CITY OF PORT PHILLIP
PORT PHILLIP PLANNING SCHEME
SECONDARY CONSENT APPROVAL
under Condition No. 2 in Planning Permit No: 742/2020
Note: This approval relates to ther indicated/highlighted area(s) only
Date: 6/09/2022 Sheet: 1 of 16

SCHEDULE OF CHANGES BY POINT ARCHITECTS DATED 21.04.2022 IS AS FOLLOWS:

POINT ARCHITECT'S RESPONSE TO THE PERMIT CONDITIONS DATED 14.01.2022 IS AS FOLLOWS:

B Section B
TP204 SCALE 1 : 100

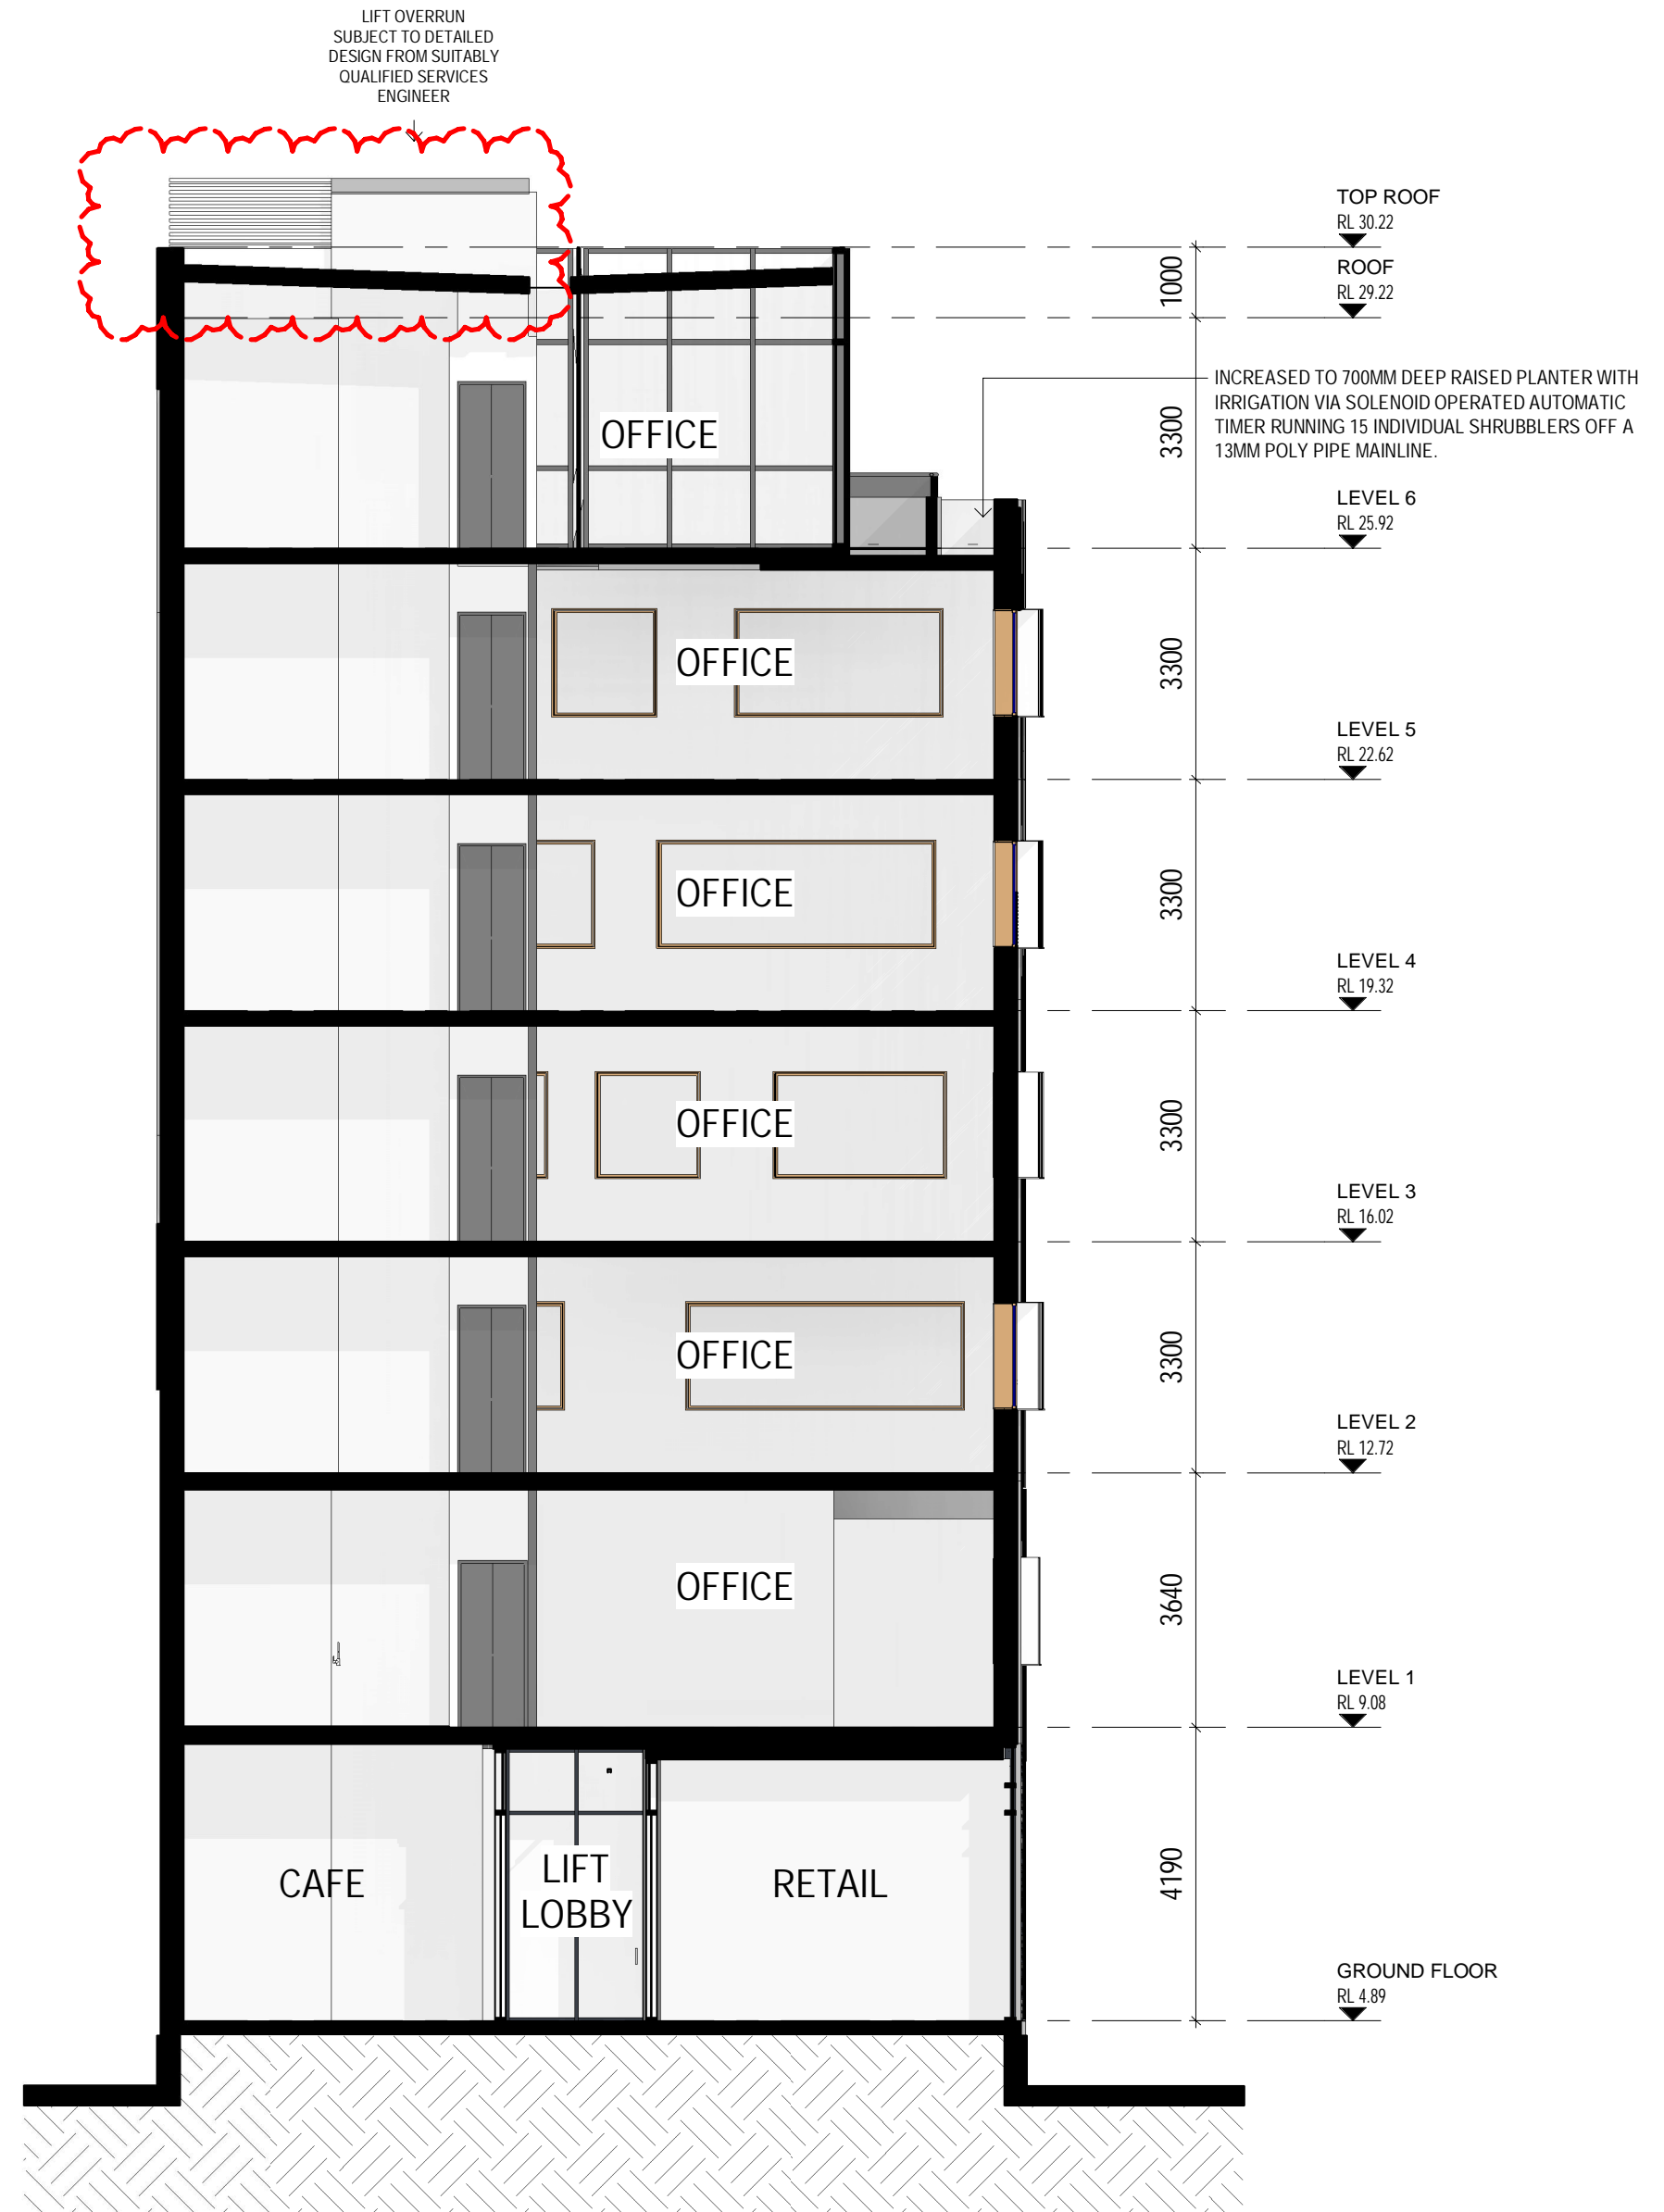
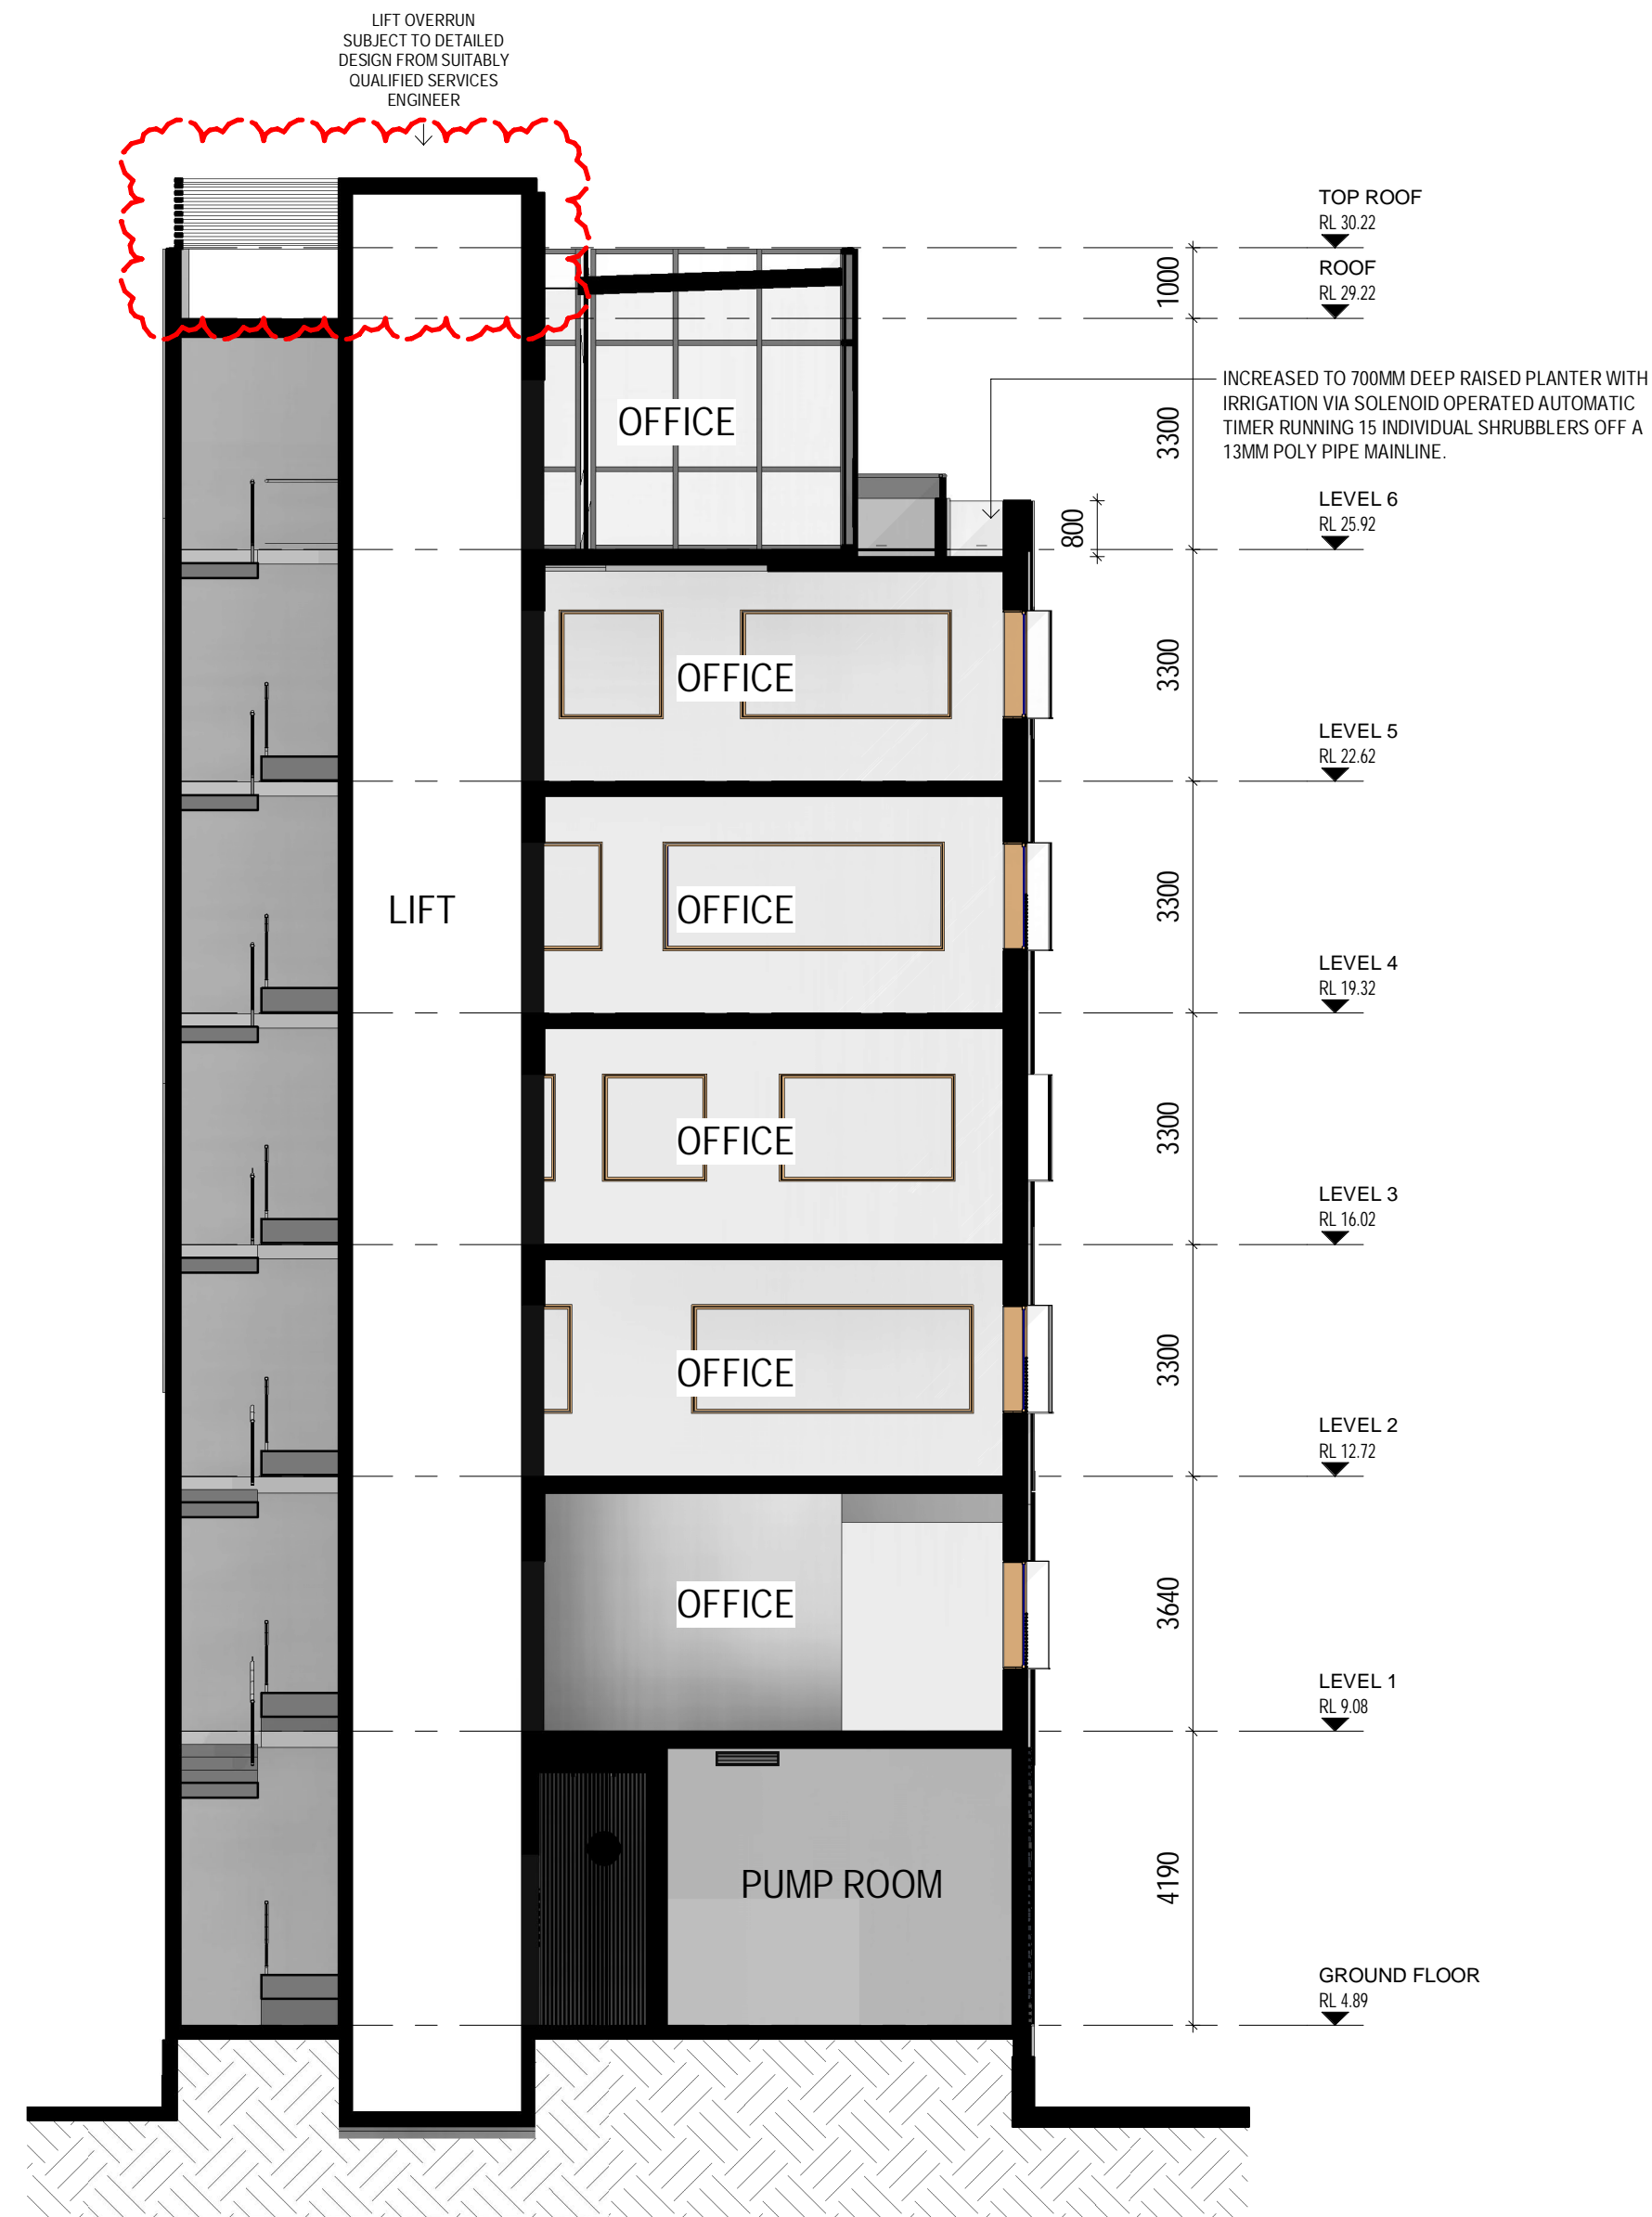
CONDITION 1(b) Increased depth of the level 6 planters together with depiction of an automatic watering system for the planter boxes.
RESPONSE: Increased planter depth depicted and note regarding automatic watering system added on TP106, TP203, TP204 and TP205.

CONDITION 1(c) Depiction of lift overruns and plant areas on the elevations.
RESPONSE: Plant screen and lift over run depicted on TP 107, TP200, TP 201, TP202, TP203, TP204 and TP205.

D Section D
TP205 SCALE 1 : 100

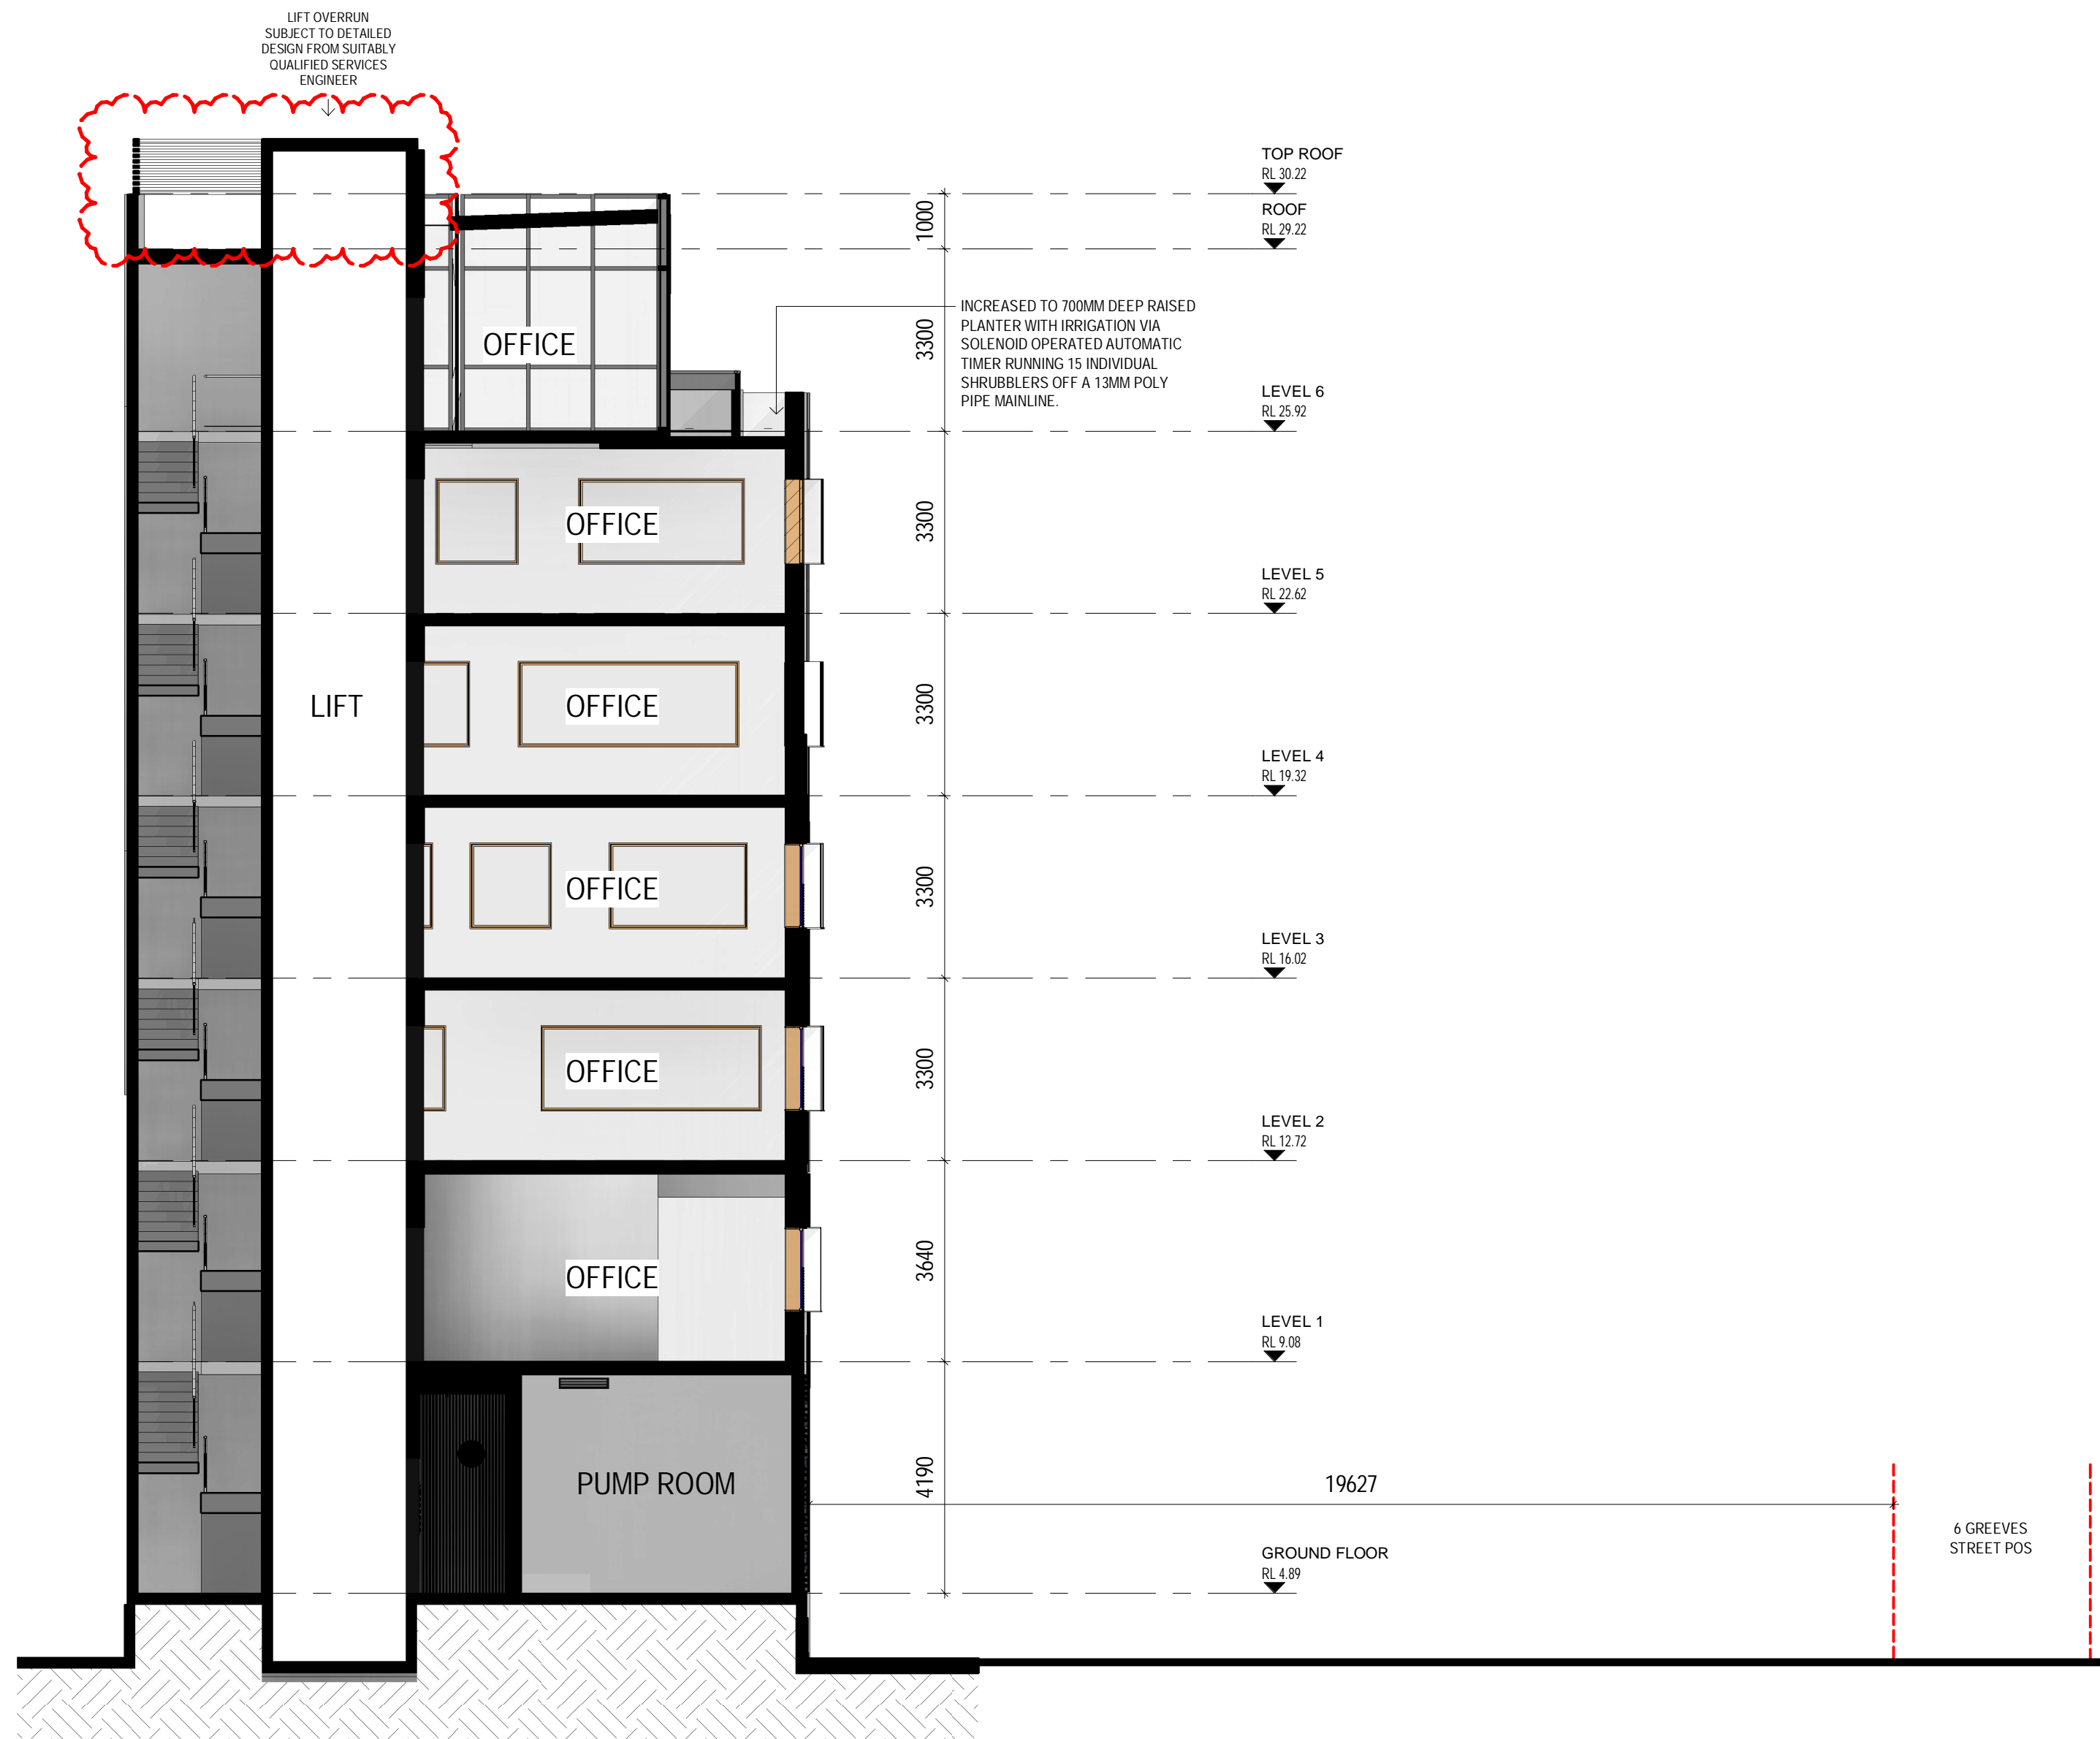
CONDITION 1(b) Increased depth of the level 6 planters together with depiction of an automatic watering system for the planter boxes.
RESPONSE: Increased planter depth depicted and note regarding automatic watering system added on TP106, TP203, TP204 and TP205.

CONDITION 1(c) Depiction of lift overruns and plant areas on the elevations.
RESPONSE: Plant screen and lift over run depicted on TP 107, TP200, TP 201, TP202, TP203, TP204 and TP205.
